LINCOLN PARK PLANNING COMMISSION

Site Plan Review

Applicant	Reefer Peterbilt
Project	Retail (Truck Parts & Supplies)
Address	3535 Fort Street, Lincoln Park, MI 48146
Date	March 9, 2022
Request	Site Plan Review

- SITE PLAN APPLICATION REQUIREMENT GENERAL NOTES:**
1. APPLICANT'S NAME AND ADDRESS ARE SHOWN IN THE TITLE BLOCK OF EACH SHEET AND ON THE TITLE SHEET.
 2. SEE TITLE SHEET T-1 FOR MORE INFORMATION.

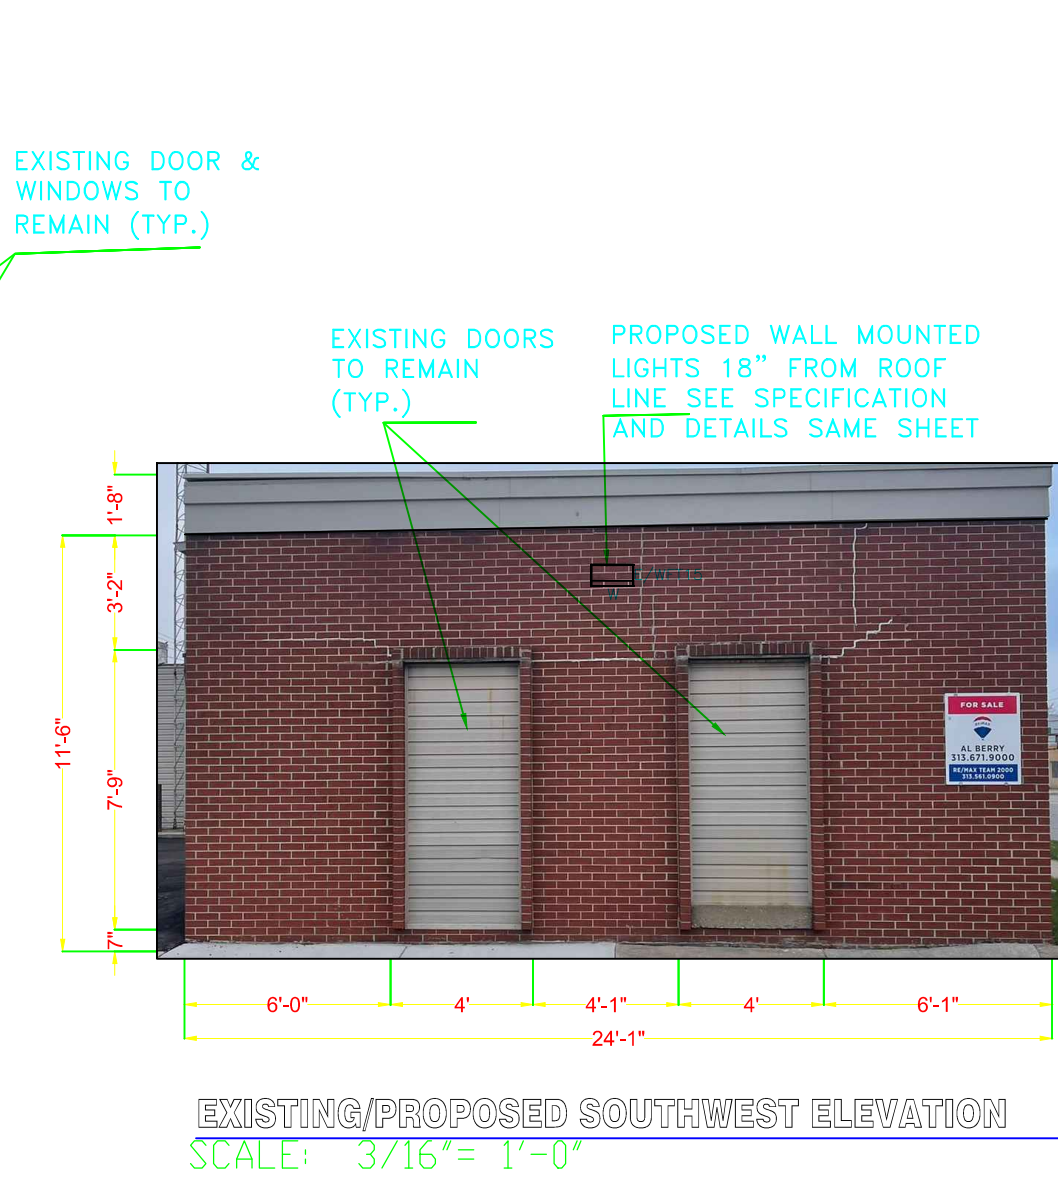
Eight (8) new wall-pack lights have been proposed to be placed on three sides of the building (facing each ROW and the alley). Specifications are shown on sheet CE4, elevations. Planning Commission to consider whether this style of lighting provides sufficient shielding to the residential use west of the site.
